Planning Board AGENDA

Re: Revised Site Plan Review comments- 404 Silver Street Agawam, MA 01001;

**Re: Battery Energy Storage System (BESS), 404 Silver Street, Agawam MA
Response to Comments – Site Plan Review Application**

Proposed Hotel

GRADING AND EROSION CONTROL PLAN

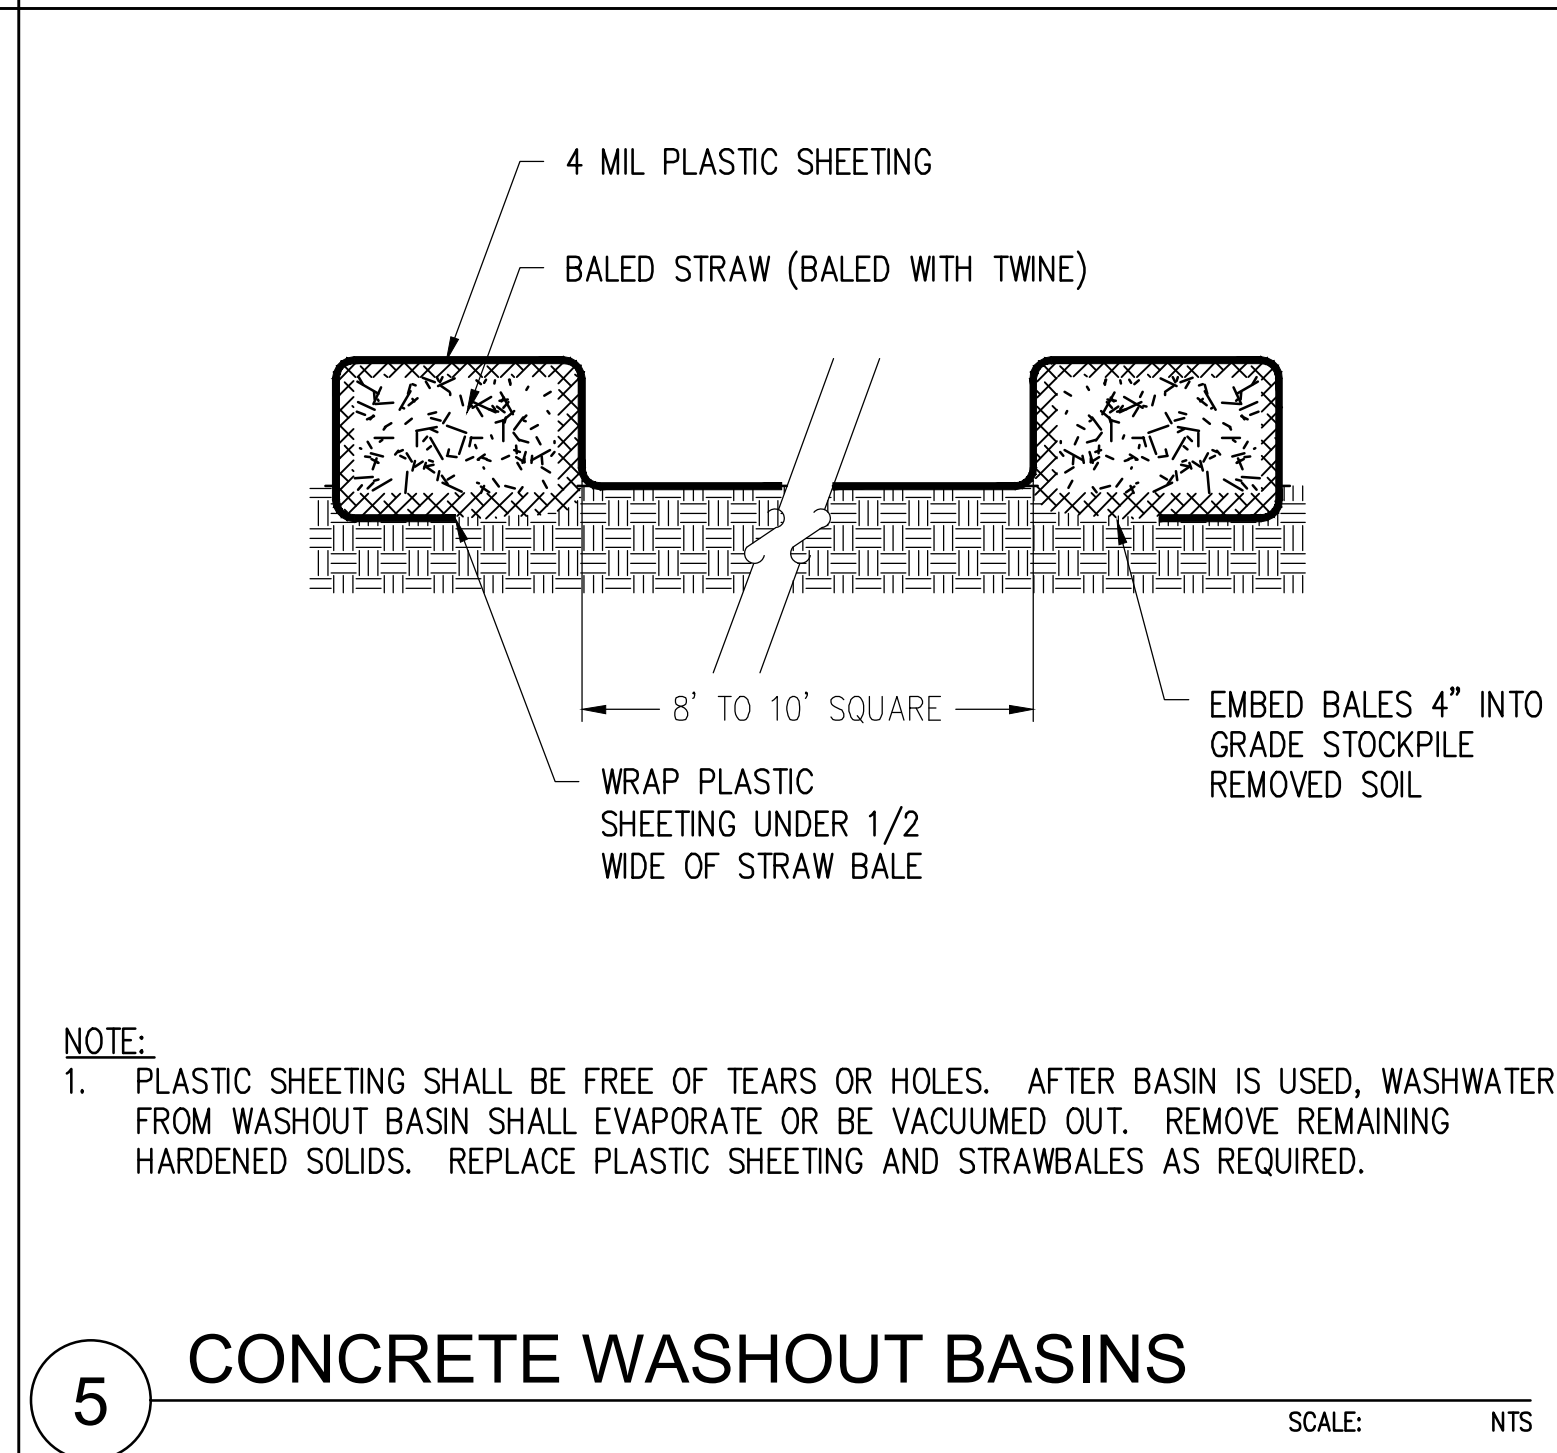
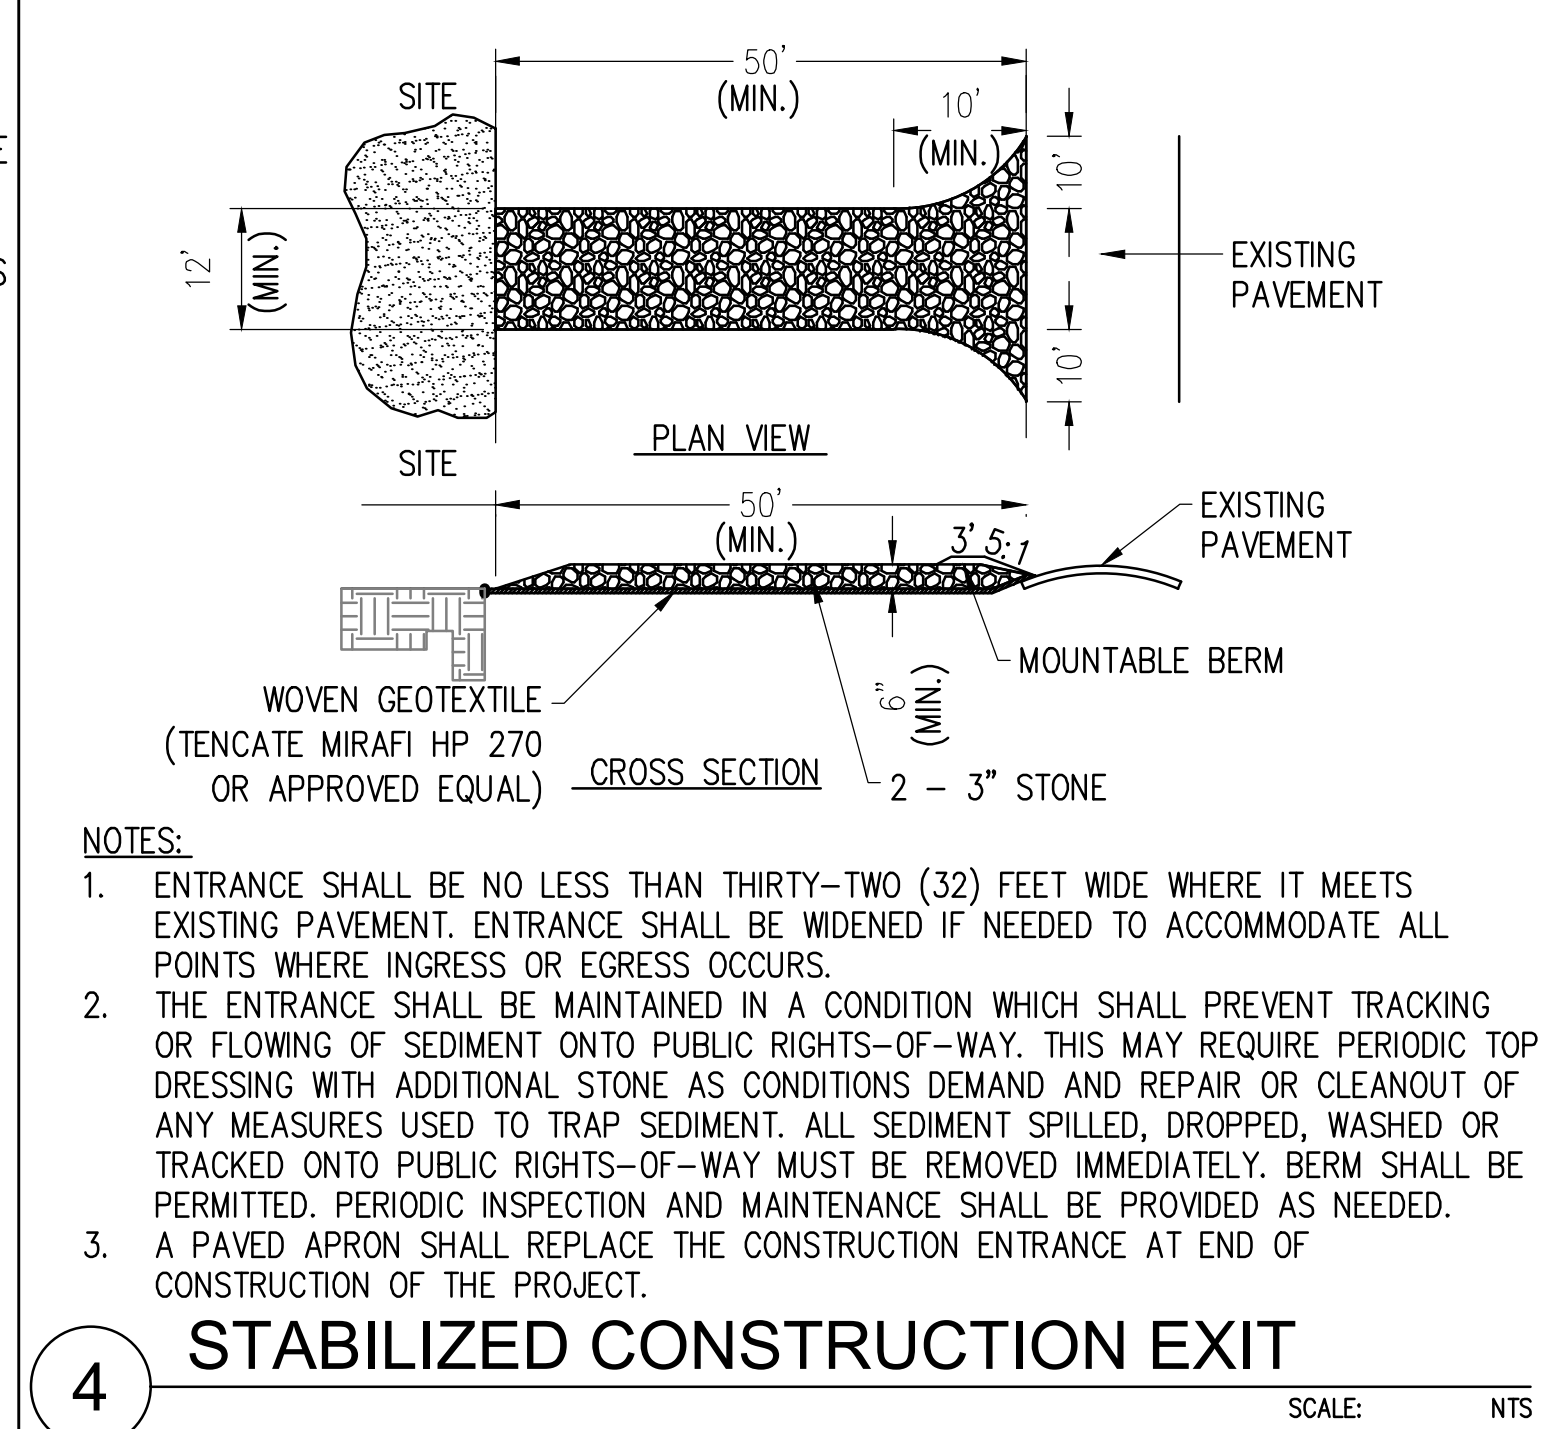
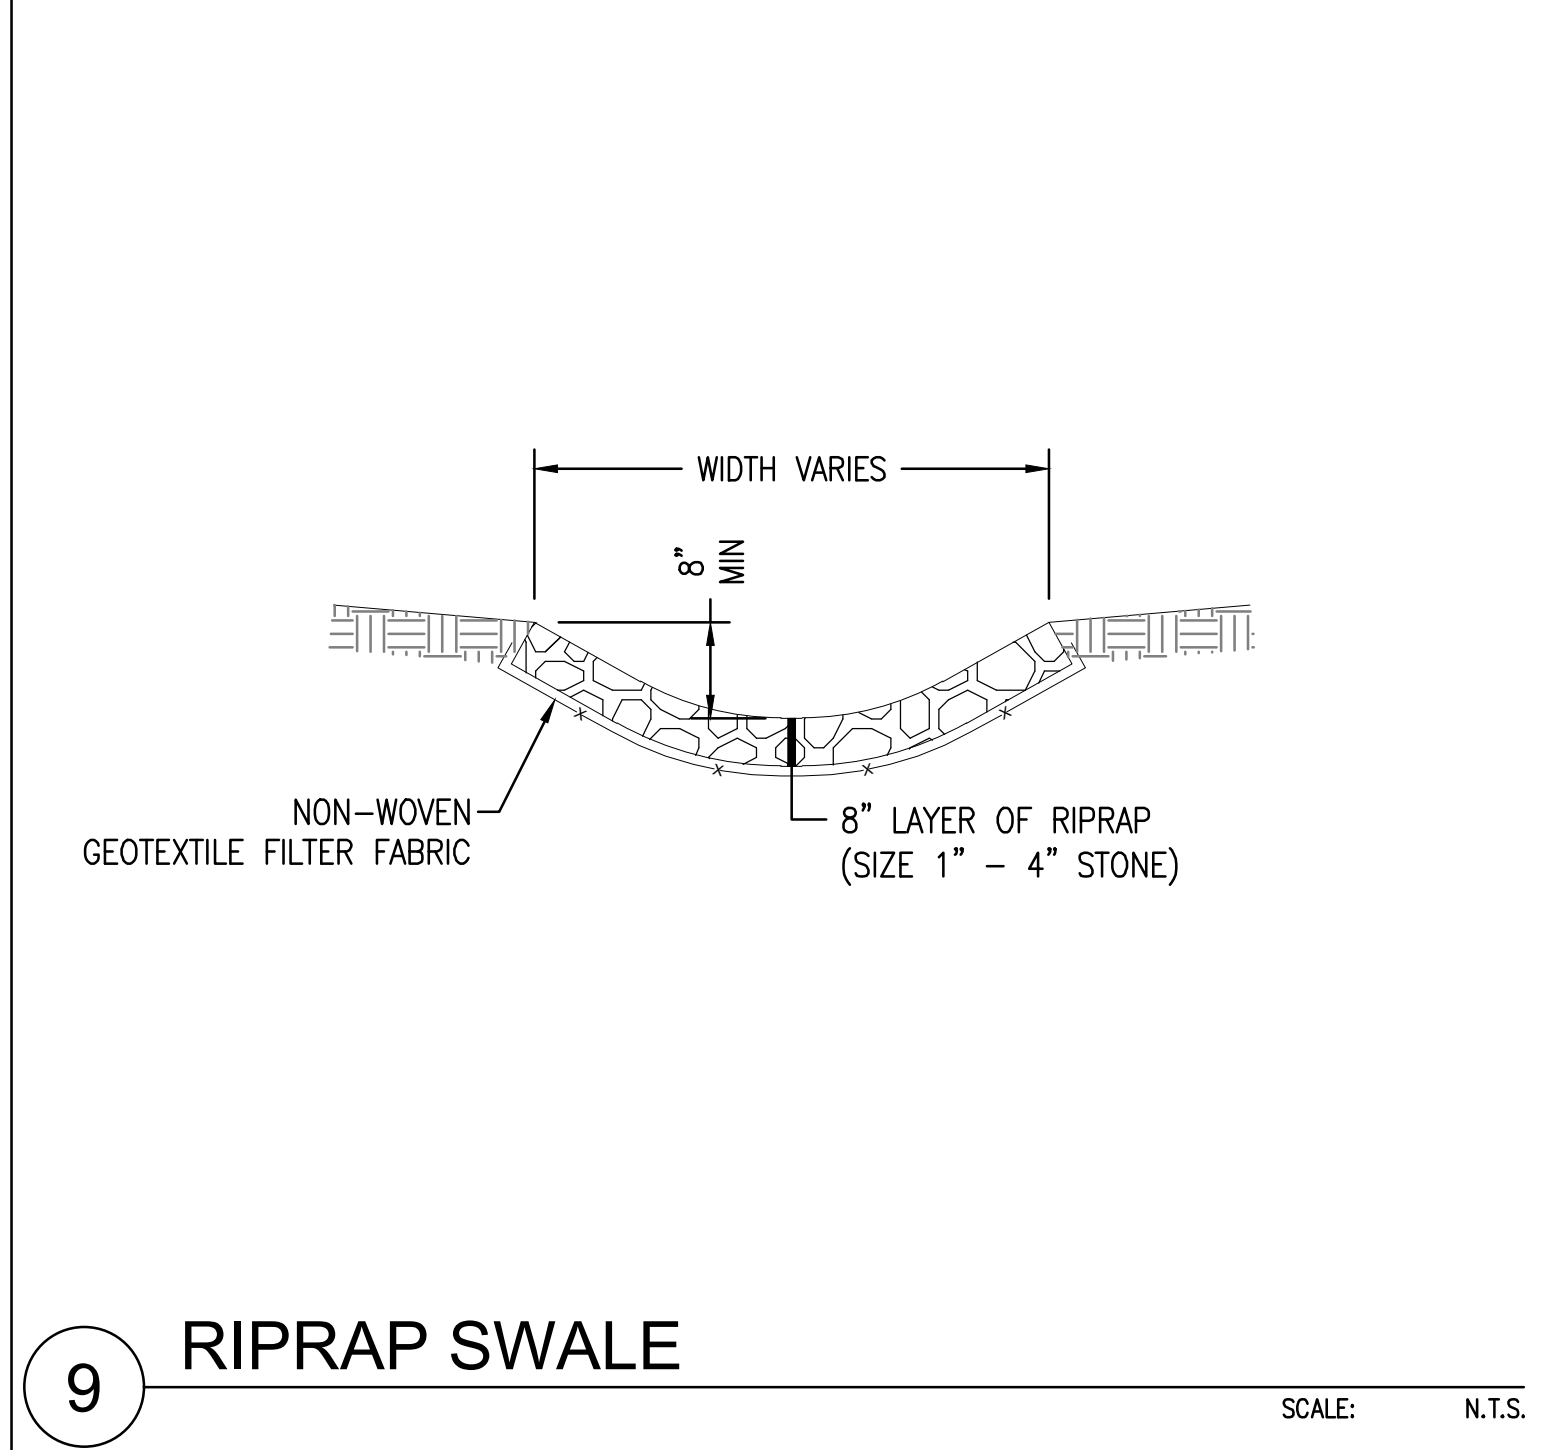
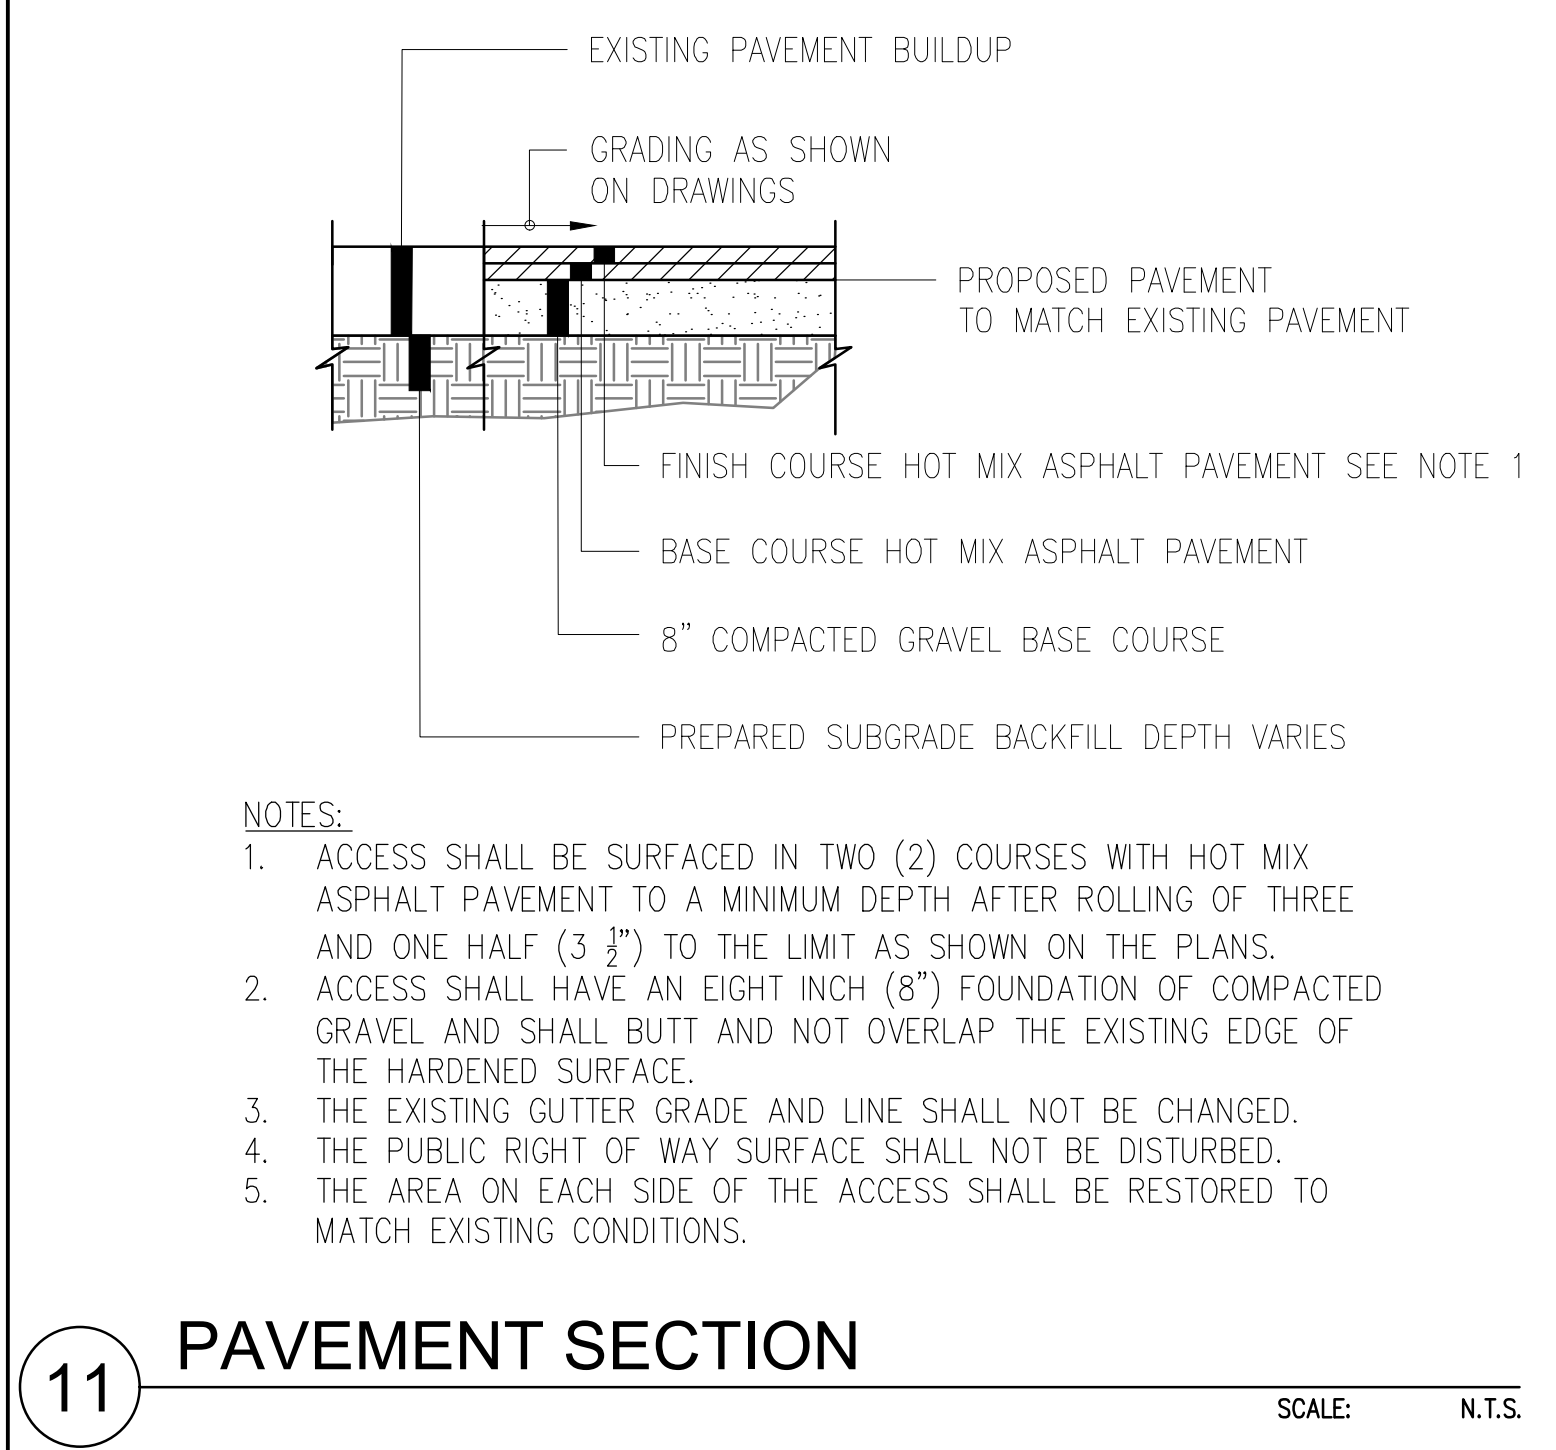
- 2. The plan calls for a silt fence to be installed on the east side of the driveway only at the very end of said driveway. Please extend the silt fence along the limit of work for the entire east side of the driveway.**

- 4. Sheet C-4.0 of the plans has a leader pointing to a riprap swale but it is unclear how that swale is graded and the extents of its location.**

The Grading and Erosion Control Plan (Sheet C-4.0), included in Attachment A, illustrates the revised silt fence location, extending along the limit of work for the entire east side of the driveway.

The riprap swale has been removed from the project plans and replaced with a stone infiltration trench as shown on the Grading and Erosion Control Plan (Sheet C-4.0) included in Attachment A.
